SITE INSTRUCTION

SI A13

PROJECT : Forestside
PROJECT # : 1331.15
DATE : Dec. 3, 2021

Title: Revisions to plans as itemized.

CONCRETE SLAB EDGE 4TH FLOOR
BUILDING A (PARTIAL PLAN)

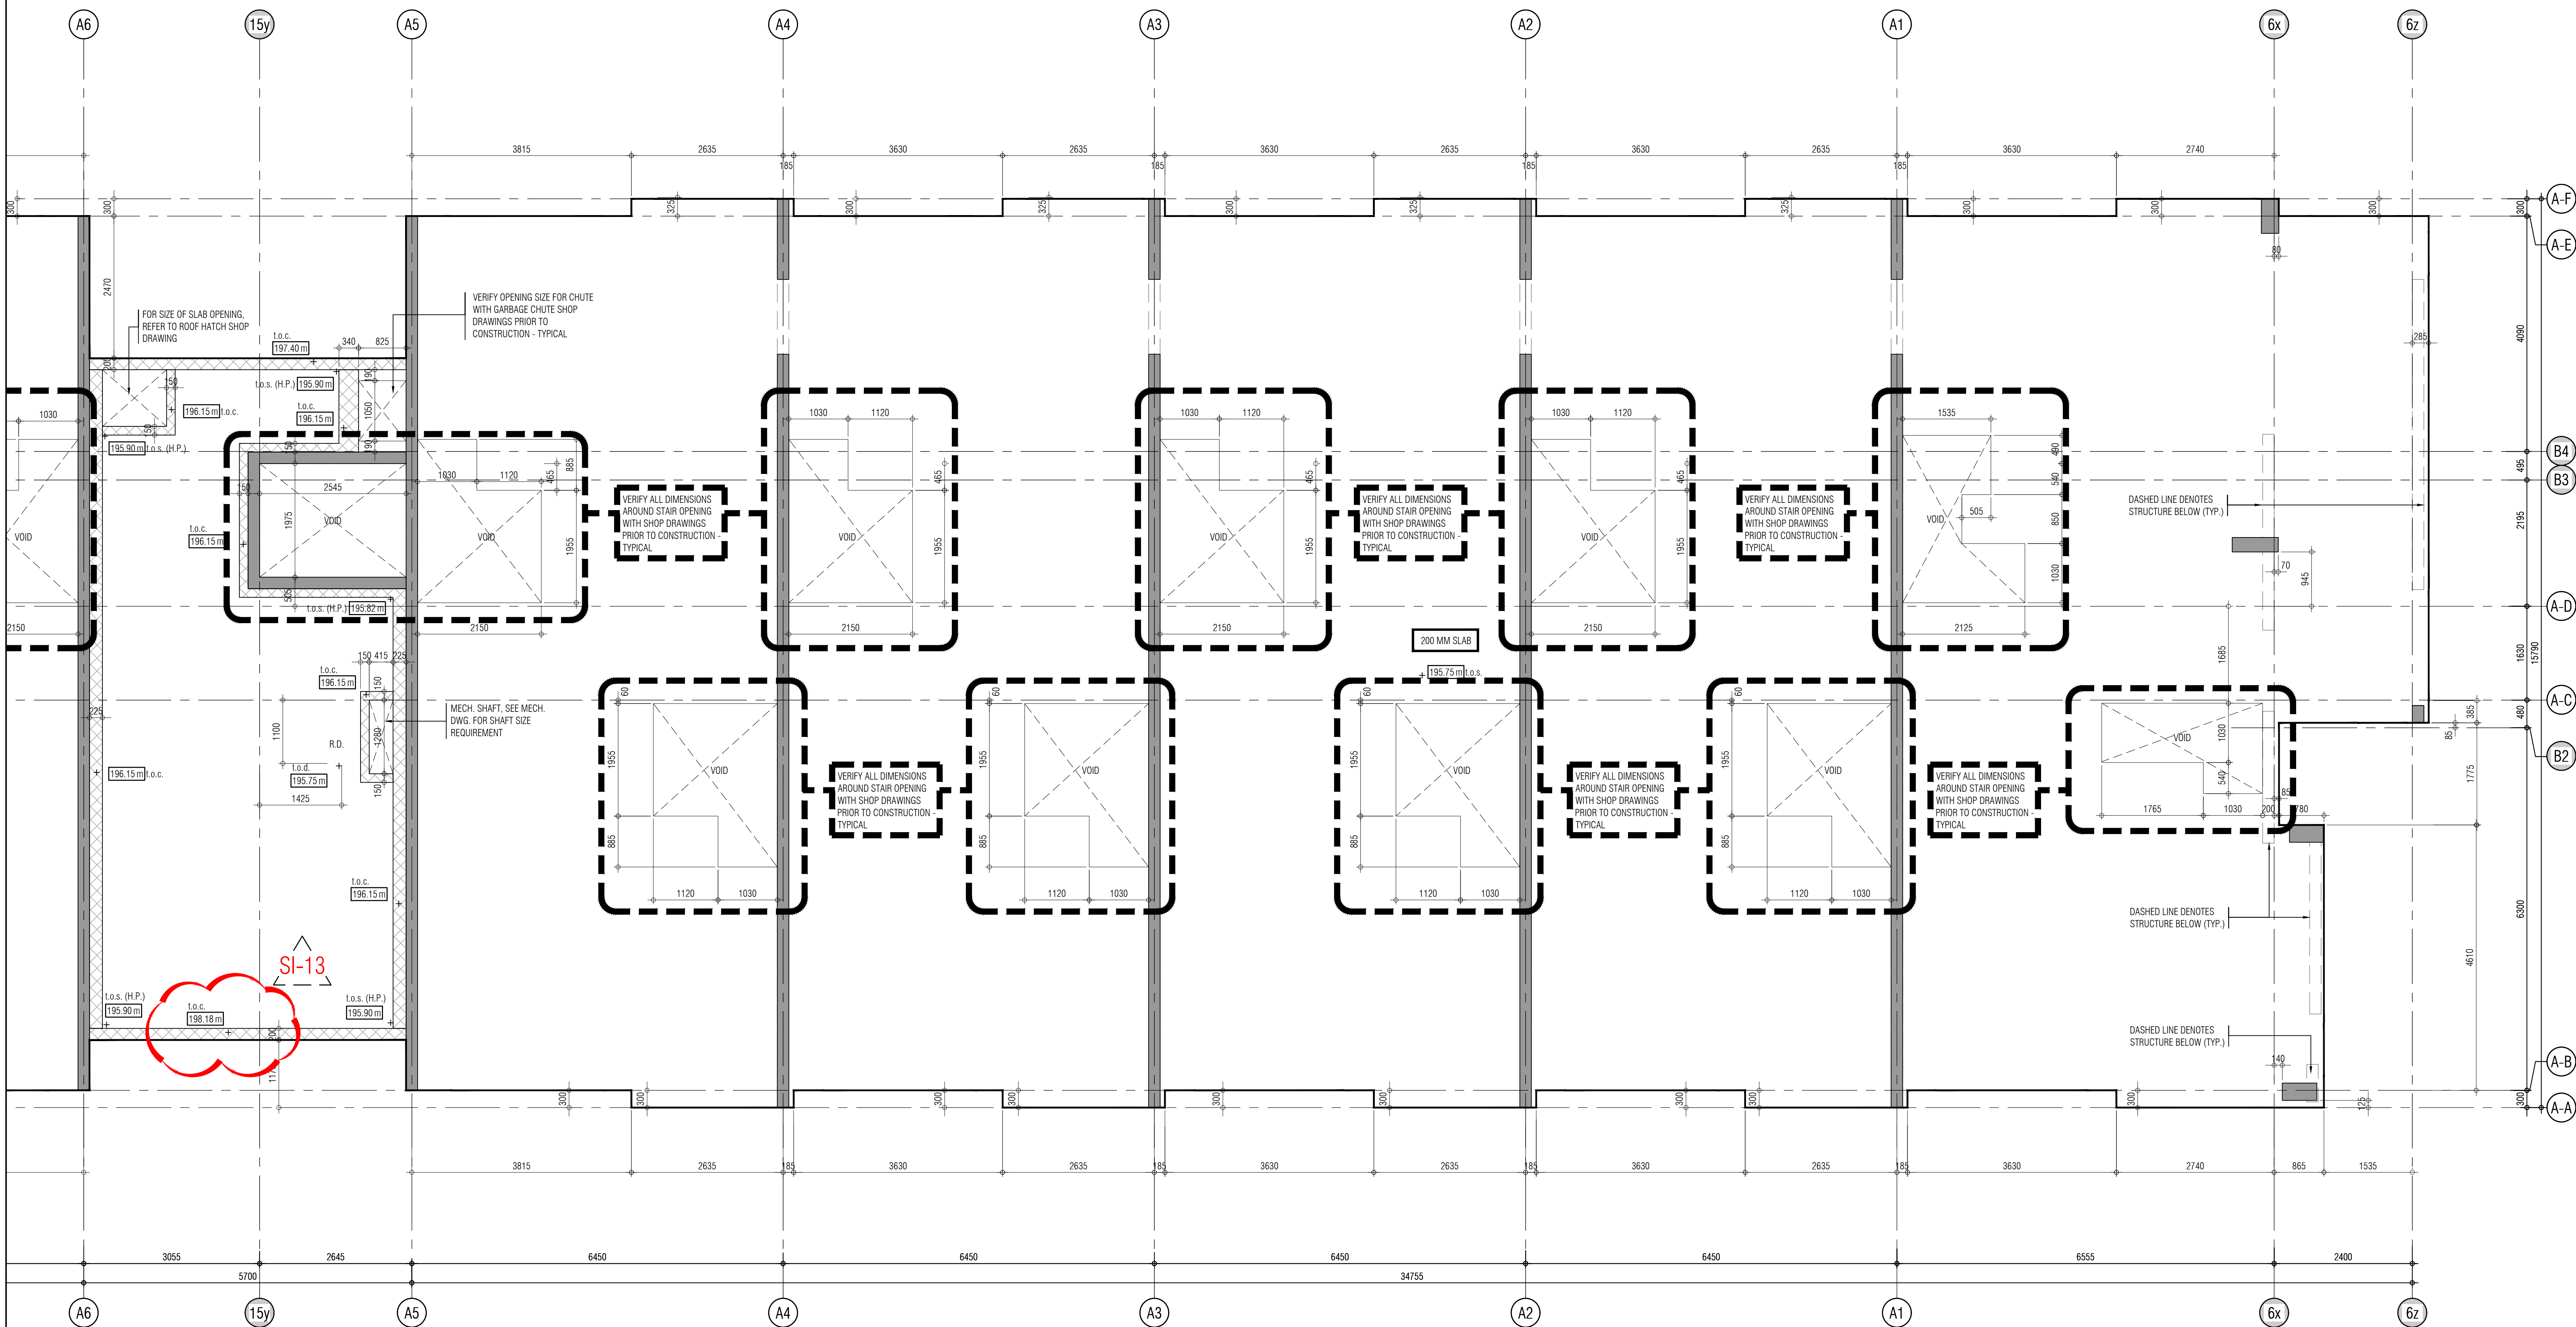
Reference:		Changes:
CS304a1, a2 CS304b1, b2 CS304c1, c2 CS304d1, d2	4th Floor Slab Edge	Revise spot elevation of higher roof parapet at front lobby wall.
A401, A401a1 A402, A402b2 A403, A403c1 A404, A404d1	Elevation Building A Elevation Building B Elevation Building C Elevation Building D	Revise height of window wall, louvre location heights to match front lobby wall parapet height.
A503	Sections	Revise dimensions, window wall, and louver location heights of front lobby wall parapet match window shop drawings.
A900	Window Schedule	Revise dimensions, window wall, and louver location heights of front lobby wall parapet match window shop drawings.

Reason: Revisions to plans of parapet heights and as per window shop drawing coordination at front lobby wall.
